VIRGINIA ELECTRIC AND POWER COMPANY
RICHMOND, VIRGINIA 23261

VIRGINIA ELECTRIC AND POWER COMPANY
SURRY POWER STATION UNITS 1 AND 2
PROPOSED TECHNICAL SPECIFICATIONS CHANGE
REDEFINITION OF EXCLUSION AREA BOUNDARY
SUPPLEMENTAL RESPONSE TO REQUEST FOR ADDITIONAL INFORMATION

Proposed Technical Specifications Change
Redefinition of Exclusion Area Boundary
Supplemental Response to Request for Additional Information

FIGURE 1

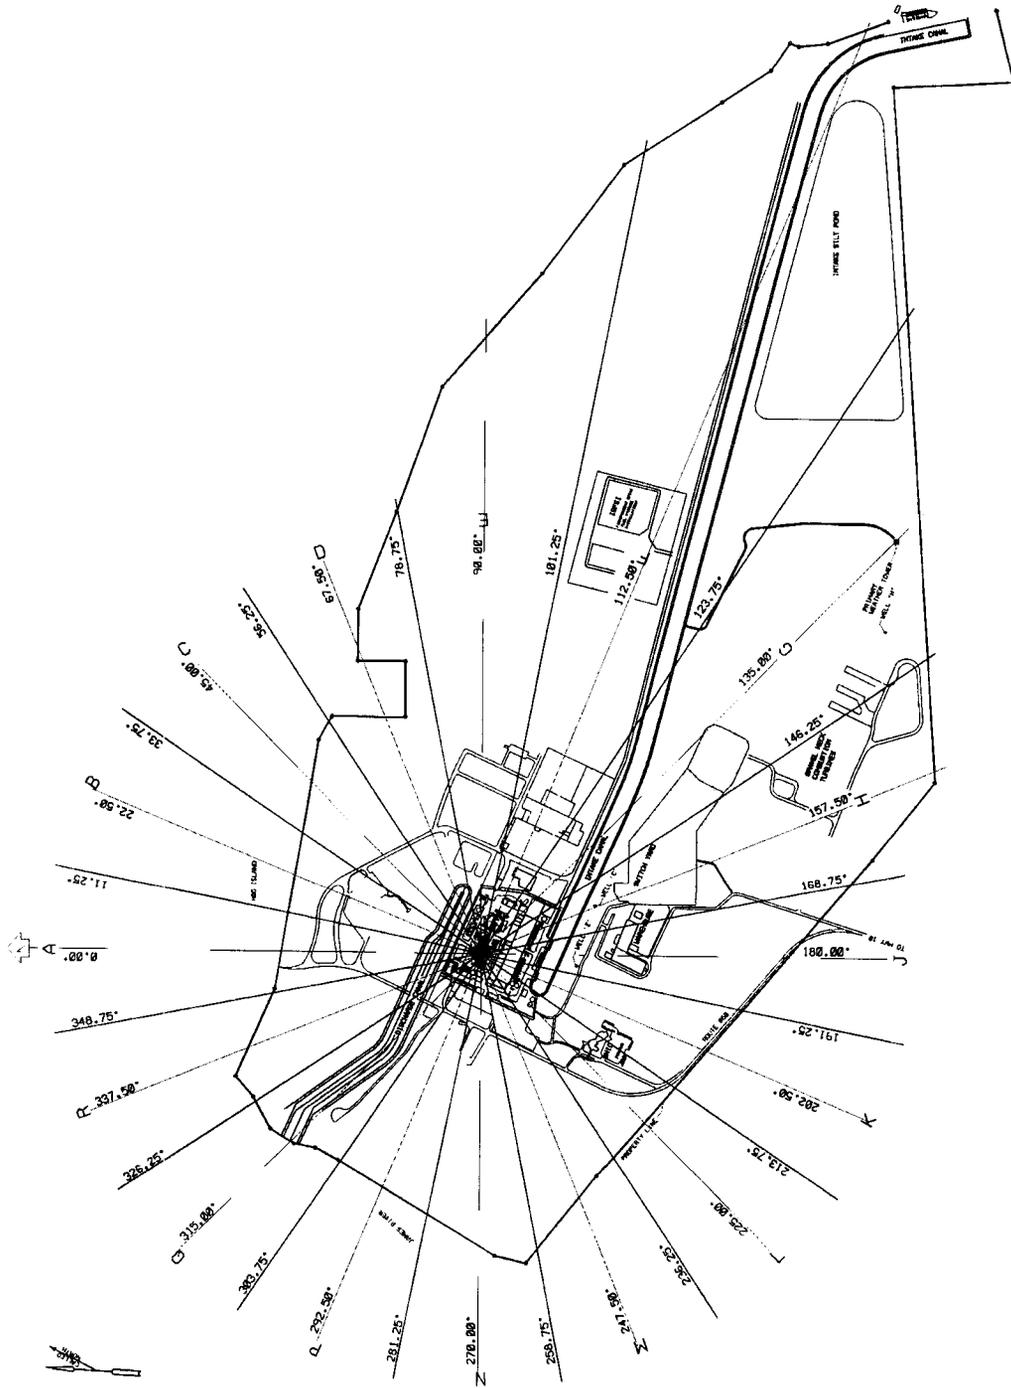
In addition to selecting minimum distances in accordance with the RG 1.145 guidance, the Surry site plan drawing was revised to adjust the position of several segments of the property line in order to correct the conversion from a property survey to a drawing. In general, the adjustment slightly increased distances to the EAB in the North, South, and West, but decreased distances in the Northeast and Southeast. Figure 1 is the revised site map that was used to determine the minimum distances from the potential source release locations to the closest point on the site boundary for each wind sector based on the RG 1.145 guidance. The attached Figure 1 replaces the Figure 1 included with our letter dated September 13, 2005.
